Federal Motor Vehicle Safety Standards; Seat Belt Assembly Anchorage, School Bus Passenger Seating and Crash Protection

ACTION: Final rule; response to petitions for reconsideration.

Figure 5 – Minimum school bus torso belt adjusted height measurement

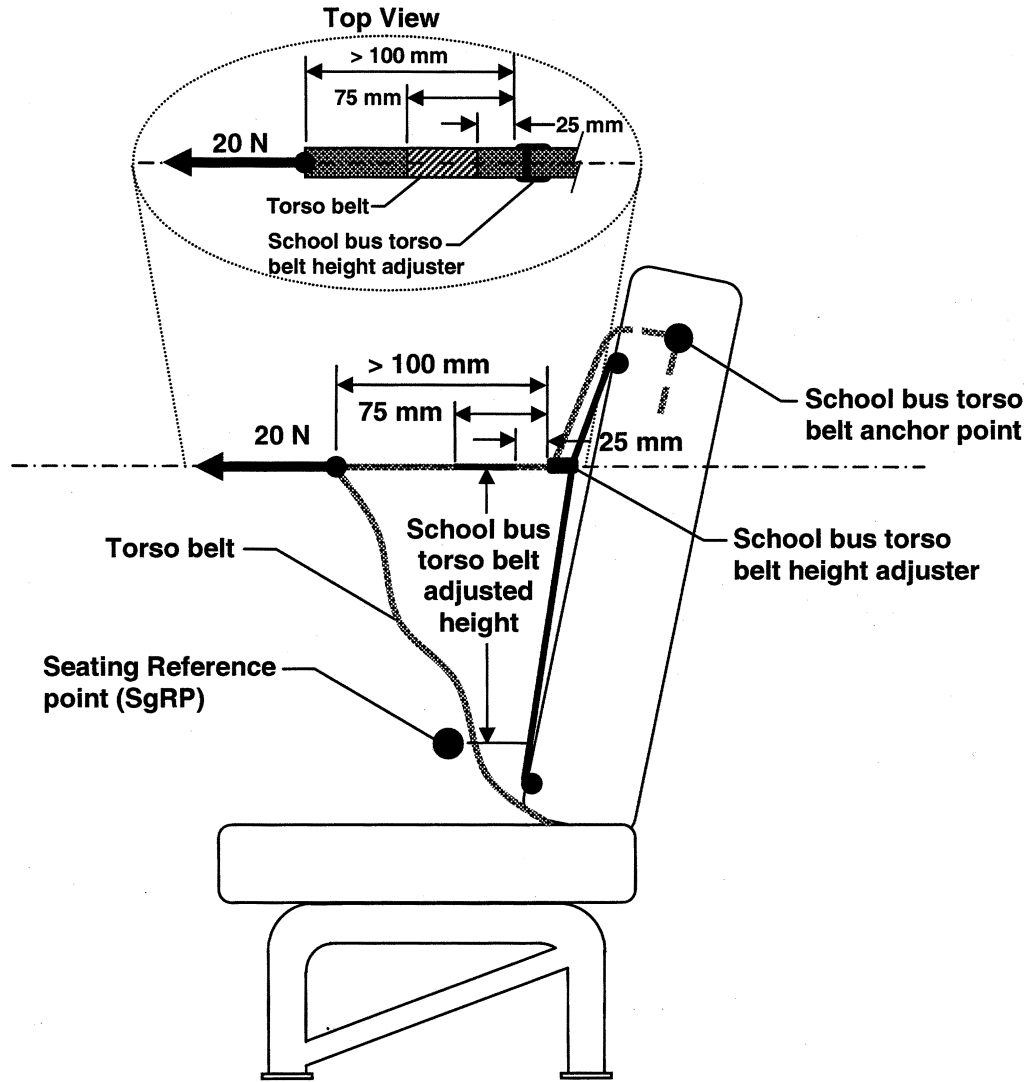
Petition for Reconsideration—In its petition for reconsideration, Blue Bird asked NHTSA to clarify the definition of "school bus torso belt adjusted height," particularly with respect to the phrase "deviates more than 10 degrees from the horizontal plane." Blue Bird stated that it is not possible to pull the webbing in a horizontal plane and maintain the original point of belt contact because the arc of the belt forces load the application device downward since the lower anchor point is fixed.

NHTSA's Response—The request is granted. We are clarifying the definition of "school bus torso belt adjusted height" and adding a new Figure 5 in FMVSS No. 210 to set forth in a clearer, more detailed manner how the torso belt adjusted height measurement will be made. The revised definition removes the confusing phrase "deviates more than 10 degrees from the horizontal plane" and adds a new figure to indicate that the measurement is made to a horizontal segment of the torso belt that is located between 25 mm to 75 mm (1 in to 3 in) forward of the adjustment device while applying a horizontal 20 N

(4.5 lb) force to the belt in the forward direction. The 20 N (4.5 lb) horizontal force is applied in the forward direction through the webbing at a location greater than 100 mm (3.94 in) forward of the adjustment device (as shown in the new Figure 5) after the retractor has been locked. Figure 5 also illustrates that slack should remain in the portion of the belt between its bottom anchorage and the point of force application. This slack allows the upper portion of the torso belt, between the point of force application and the adjuster, to be pulled in a horizontal plane. We believe these amendments address the petitioner's concerns.

School bus torso belt adjusted height means the vertical height above the seating reference point (SgRP) of the horizontal plane containing a segment of the torso belt centerline located 25 mm to 75 mm forward of the torso belt height adjuster device, when the torso

belt retractor is locked and the torso belt is pulled away from the seat back by applying a 20 N horizontal force in the forward direction through the webbing at a location 100 mm or more forward of the adjustment device as shown in Figure 5.
